RETREAT AT TIMBERRIDGE FILING NO. 3

COUNTY OF EL PASO, STATE OF COLORADO

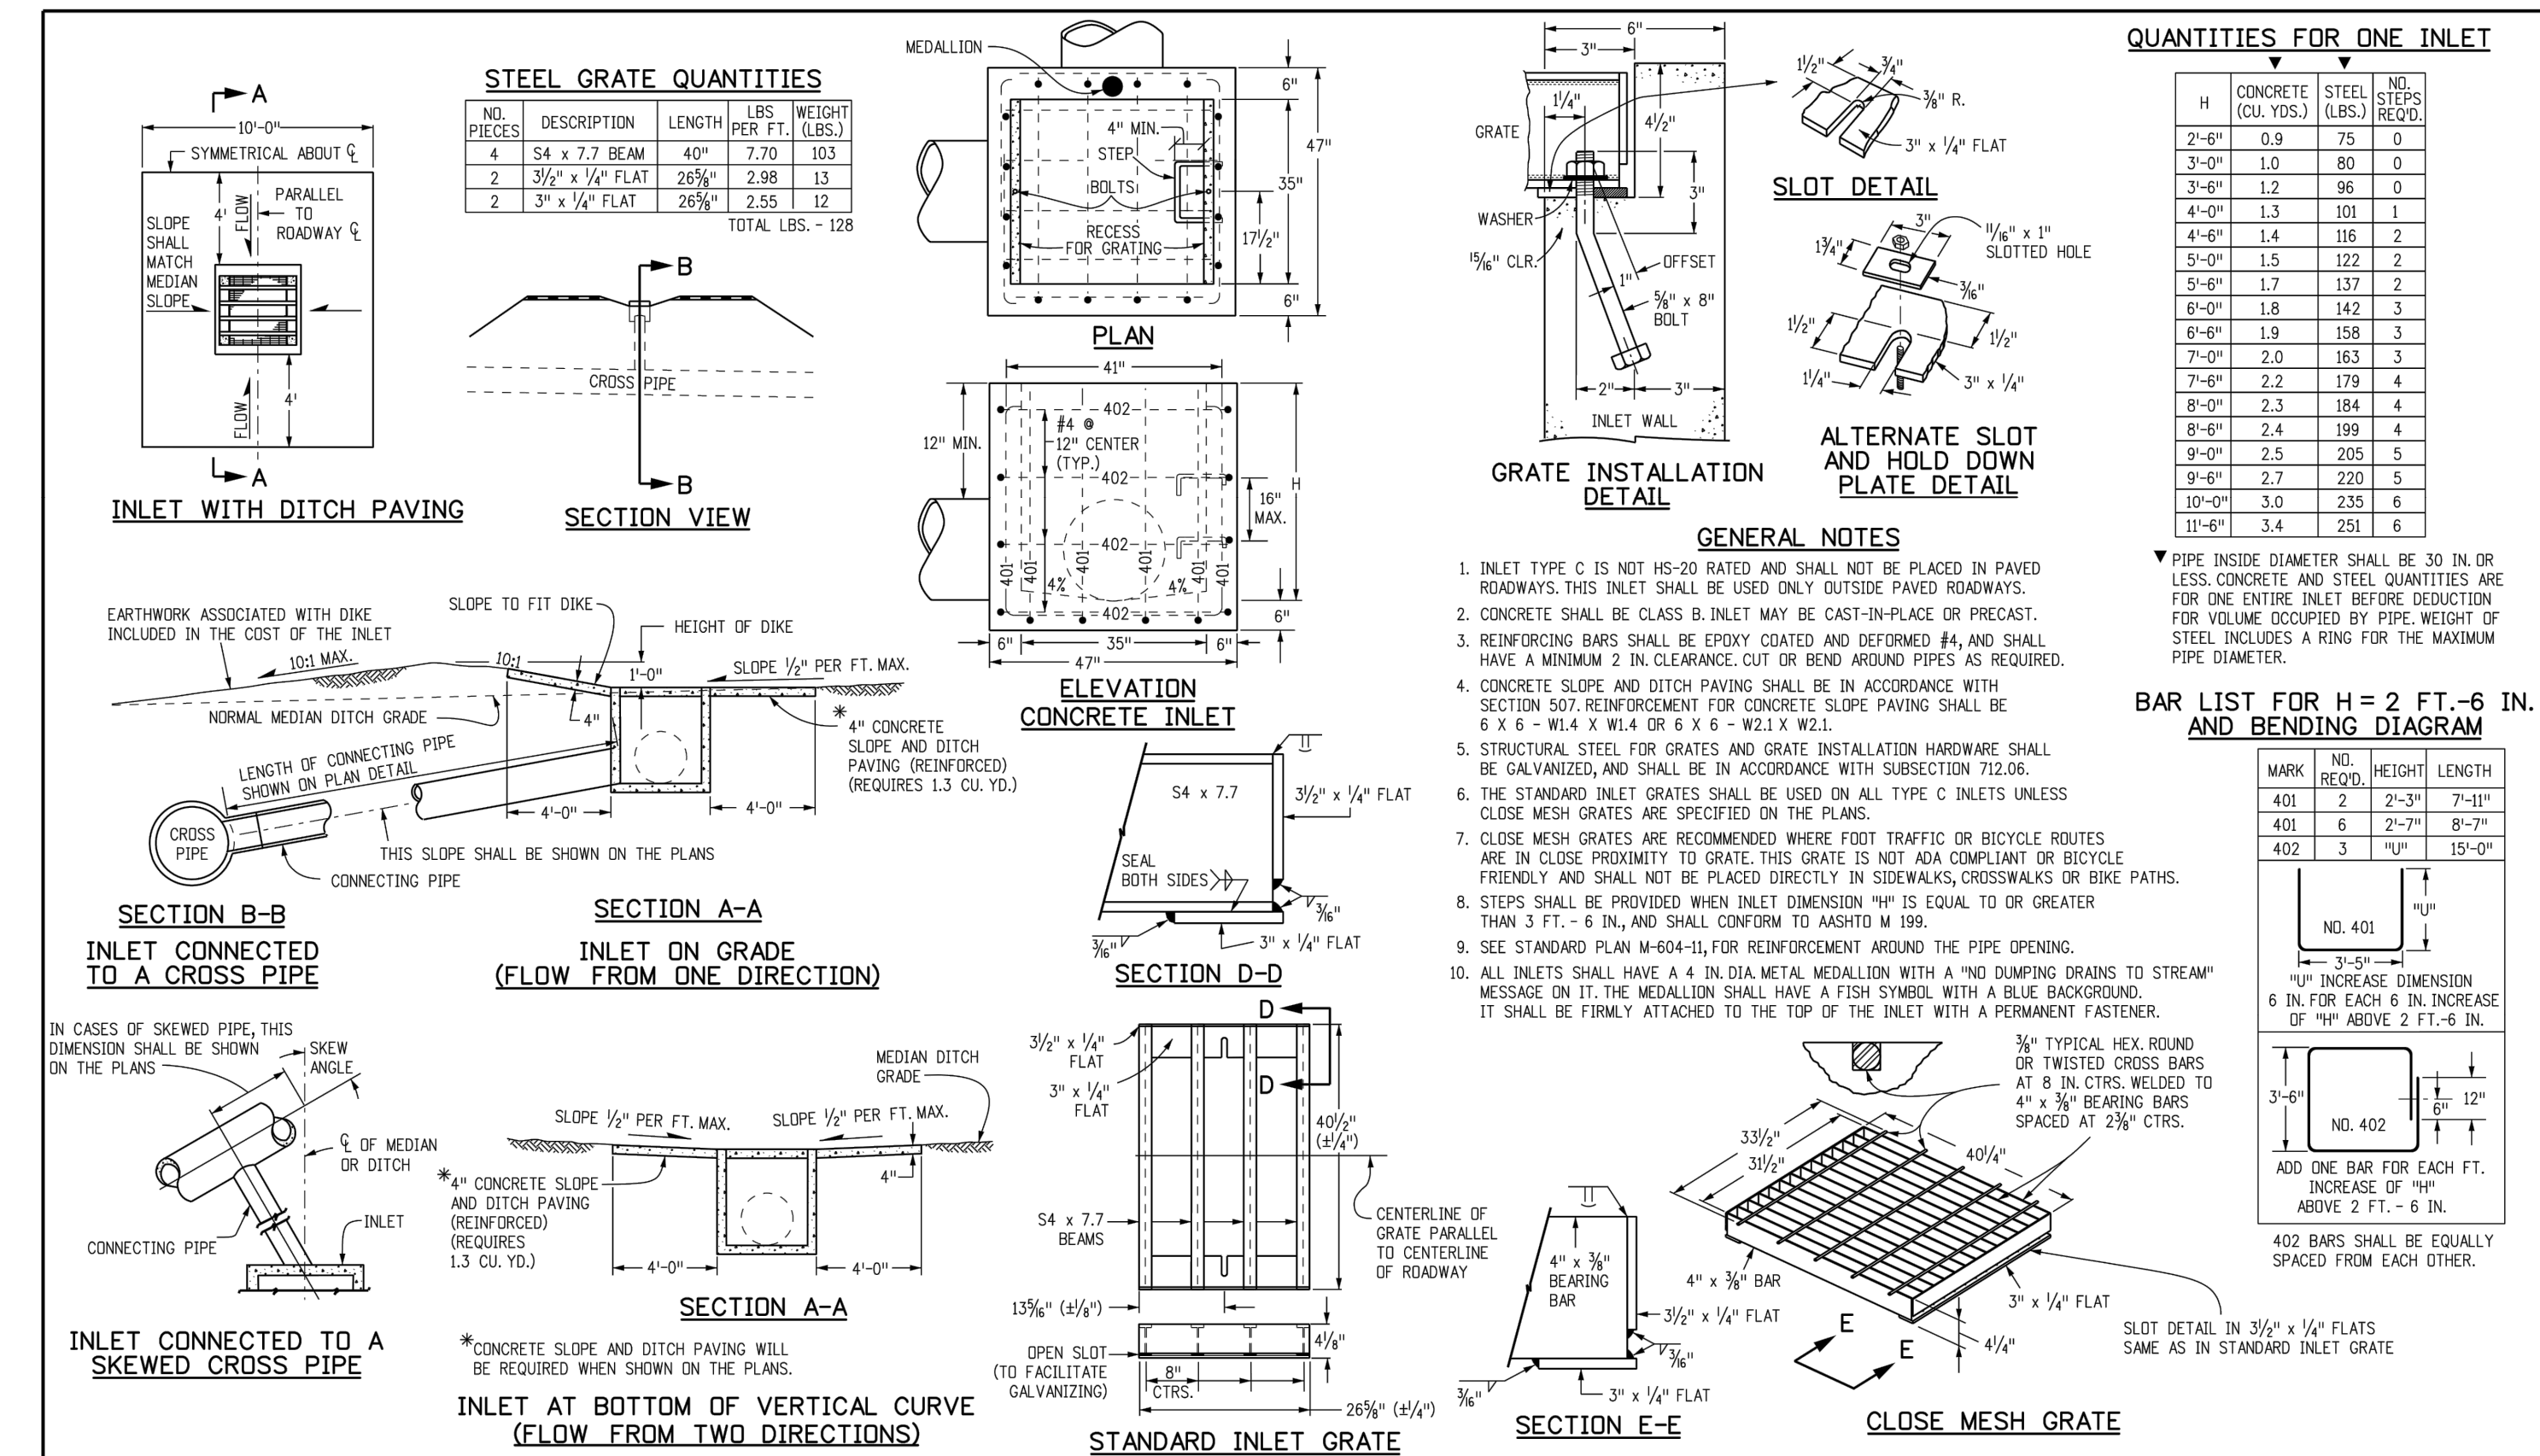
Computer File Information	Sheet Revisions	Colorado Department of Transportation	INLET, TYPE C	STANDARD PLAN NO.
Creation Date: 07/04/12 Last Modification Date: 07/04/12 Full Path: www.coloradodot.info/business/designsupport/ Drawing File Name: 6040100101.dgn CAD Ver: MicroStation V8	Date: _____ Comments: _____	4201 East Arkansas Avenue Denver, Colorado 80222 Phone: (303) 757-9083 Fax: (303) 757-9920	Issued By: Project Development Branch July 4, 2012	M-604-10
Initials: DD Initials: LTA Initials: LTA Units: English		Project Development Branch DD/LTA		Sheet No. 1 of 1

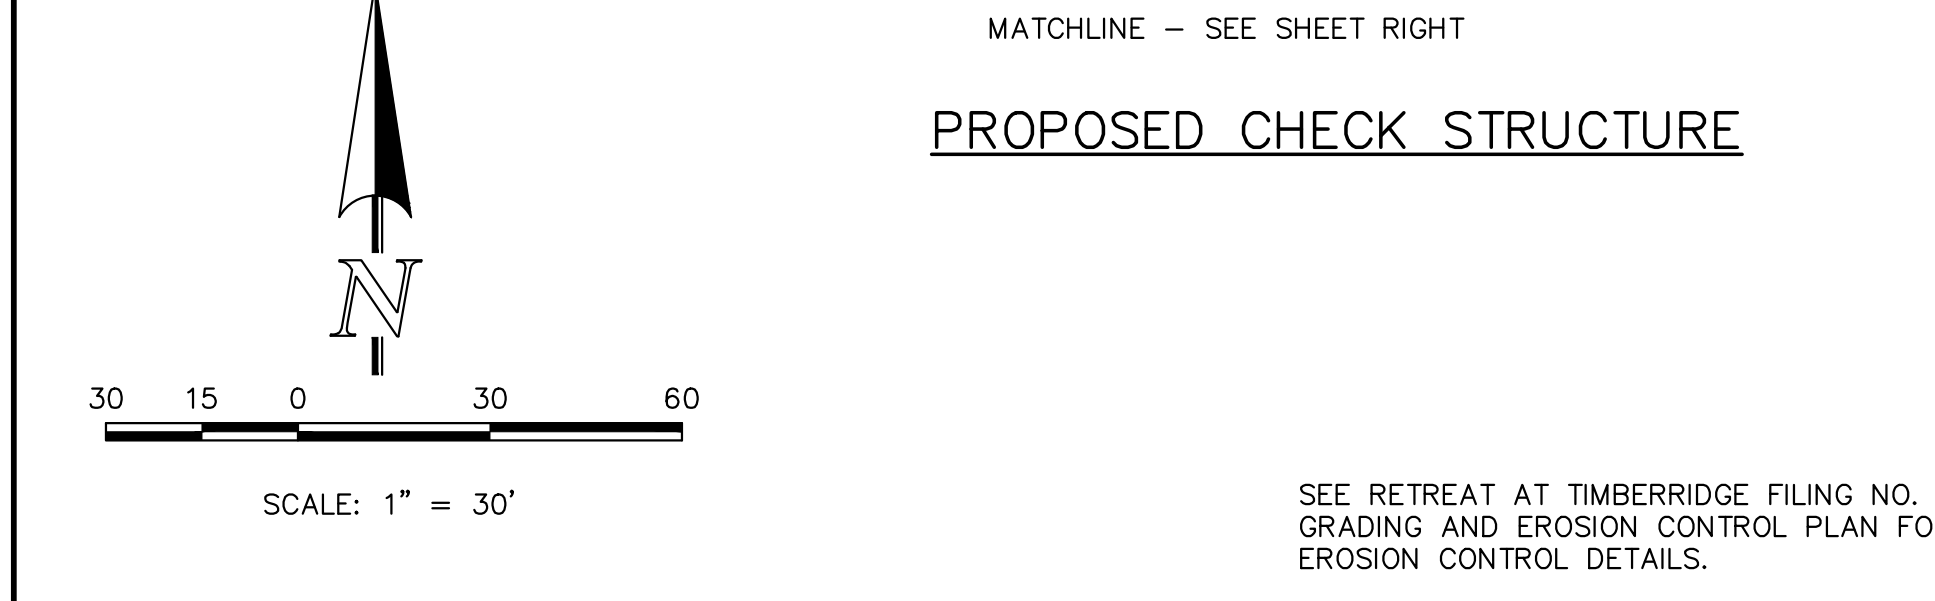
NO.	REVISION	DATE
1	REVISED PER COUNTY COMMENTS	9/22/23
2	REVISED PER COUNTY COMMENTS	10/31/23
3	REVISED PER ROADWAY ELEVATION CHANGE	1/26/24
4	REVISED PER COUNTY COMMENTS	4/18/24

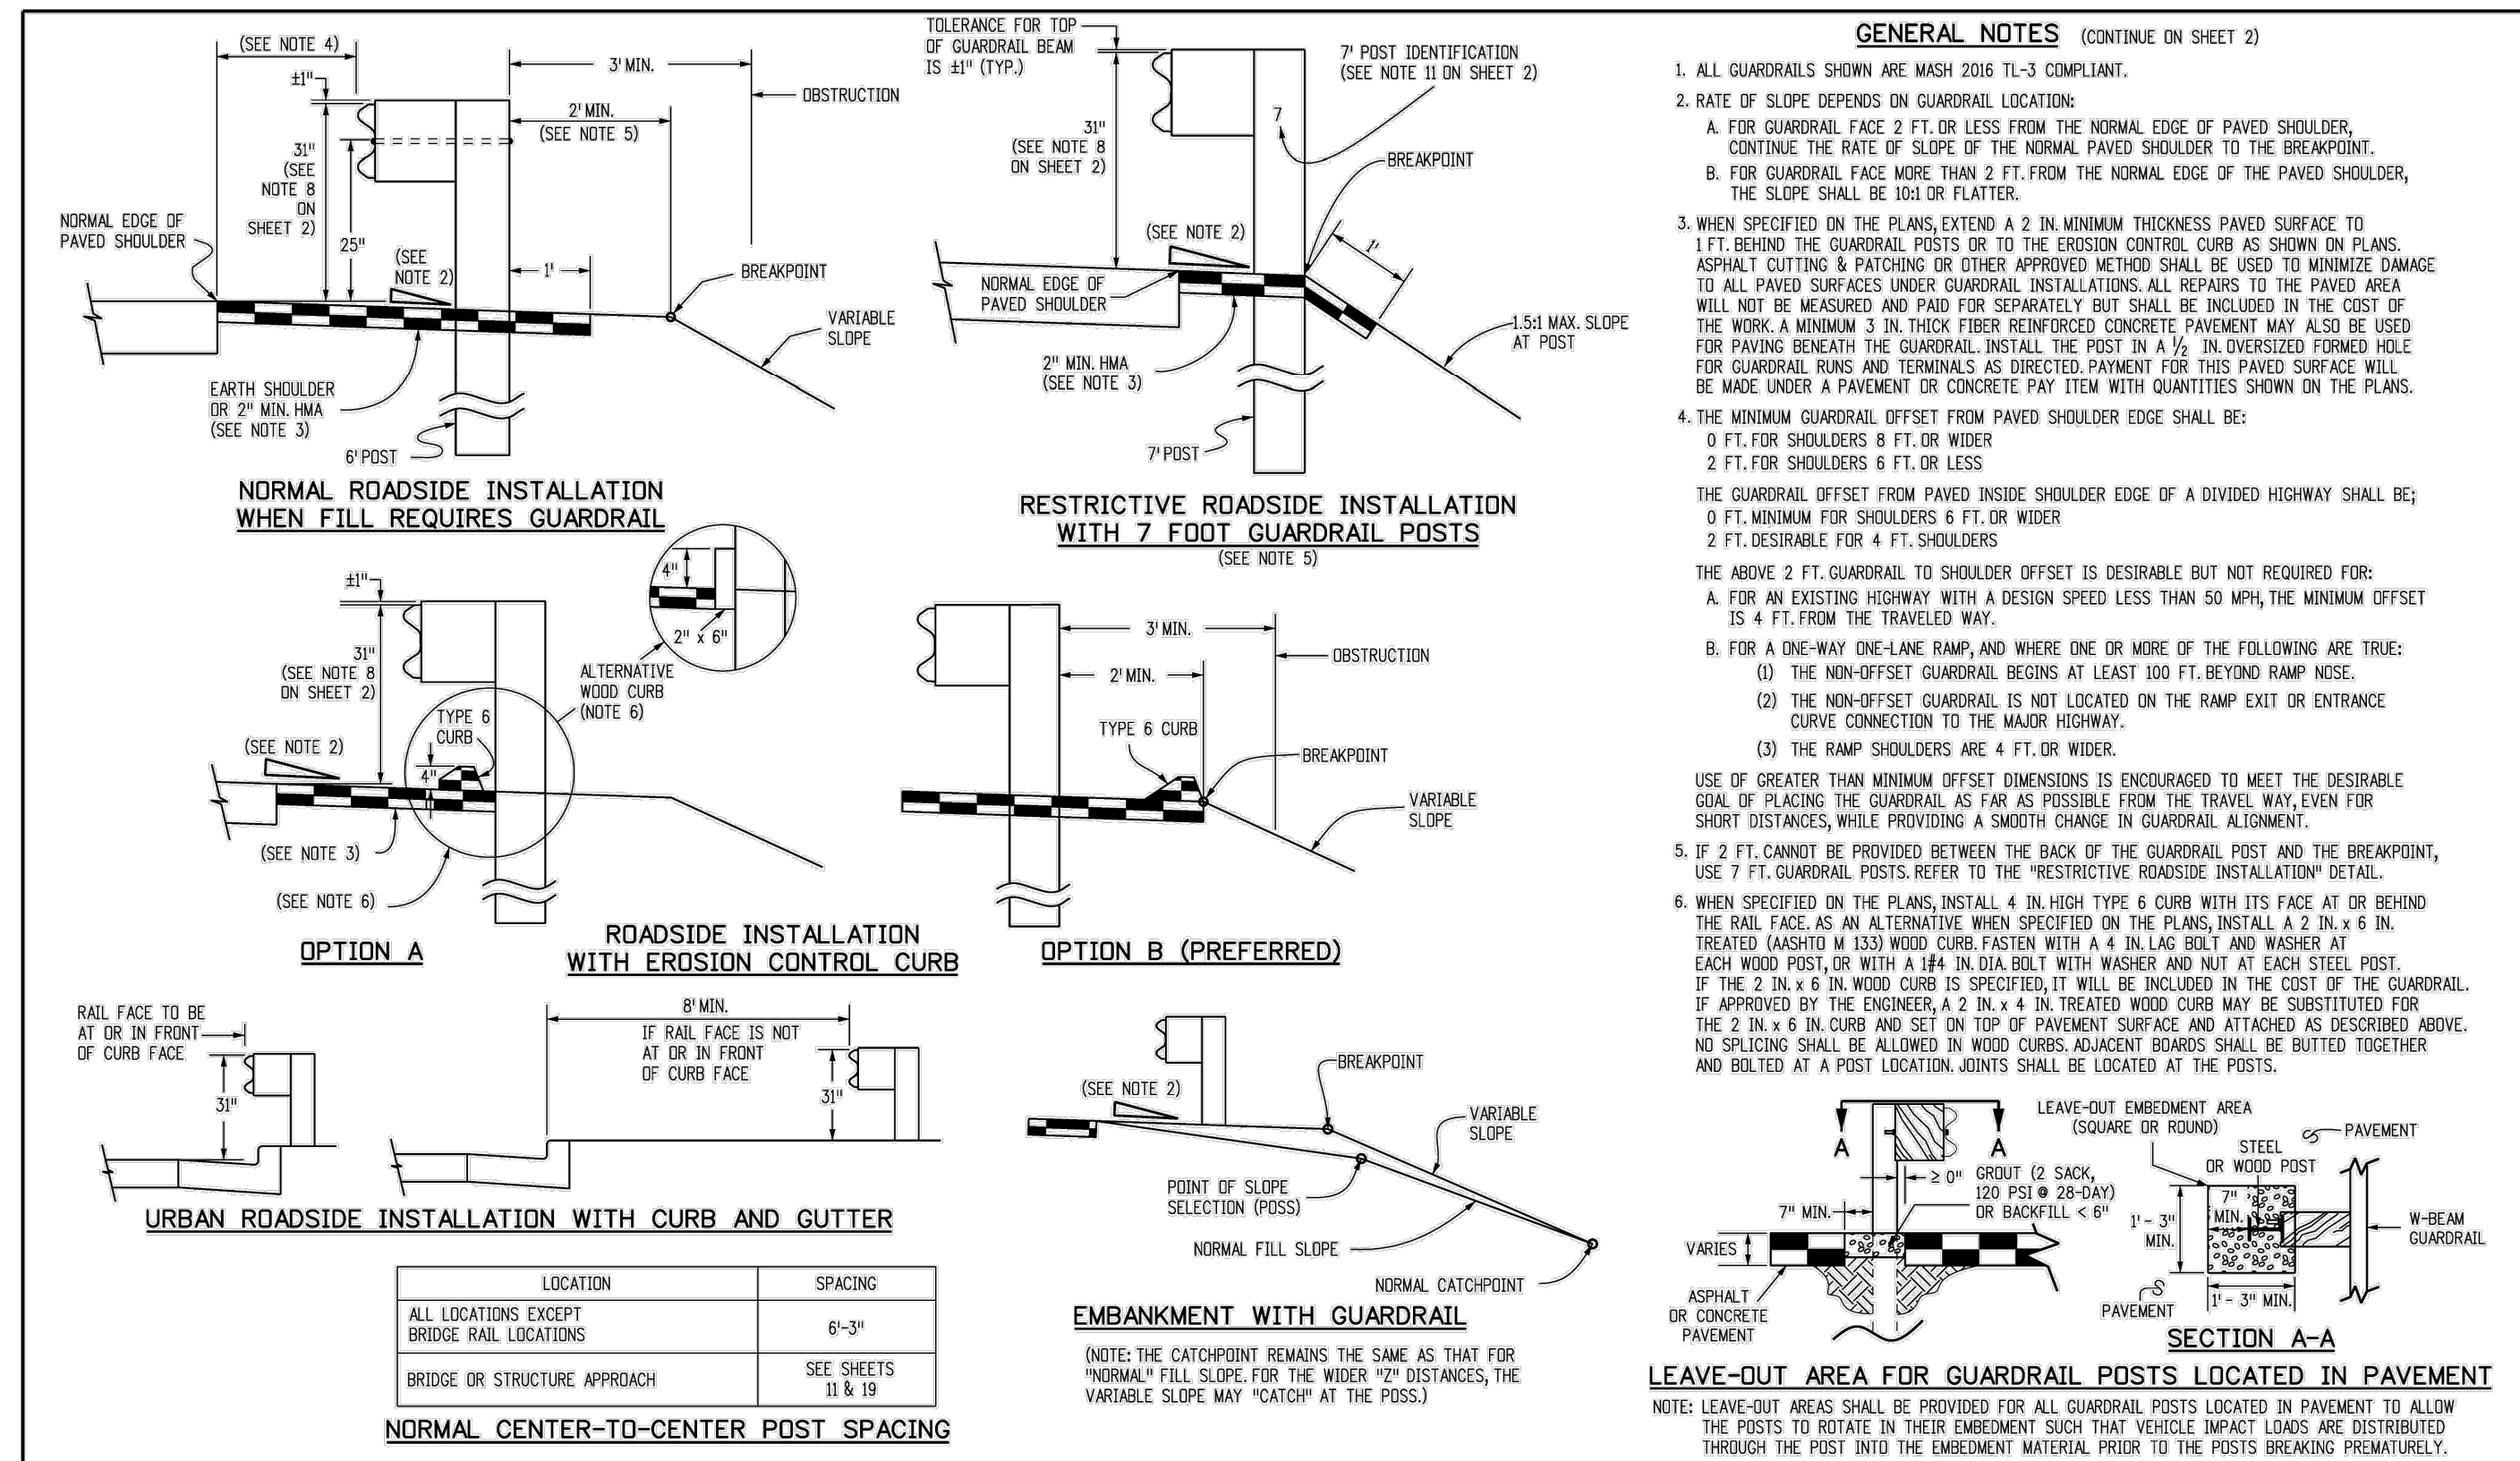
Computer File Information	Sheet Revisions	Colorado Department of Transportation	MIDWEST GUARDRAIL SYSTEM (MGS) TYPE 3 W-BEAM 31 INCHES	STANDARD PLAN NO. M-606-1
Creation Date: 07/31/19 Designer Initials: JBR Last Modification Date: 03/05/20 Detailer Initials: LTA CAD Ver.: MicroStation V8 Scale: Not to Scale Units: English	Date: 03/05/20 Comments: Revised per Note 1 to show MASH compliant	2829 West Howard Place CDOT HQ, 3rd Floor Denver, CO 80204 Phone: 303-757-9021 FAX: 303-757-9868	Issued by the Project Development Branch: July 31, 2019	Project Sheet Number:
